Public Interpretation # 010

Rule 11.7.3 states;

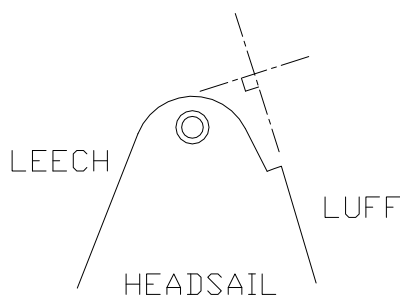
1. With reference to the sketch below, at what point is the leech of the headsail considered to commence?

Interp.	Question	Answer	Rule	Notes
PI 010	1.	The leech is considered to commence at the aft head point.		The aft head point shall be as defined in ERS G.5.5.
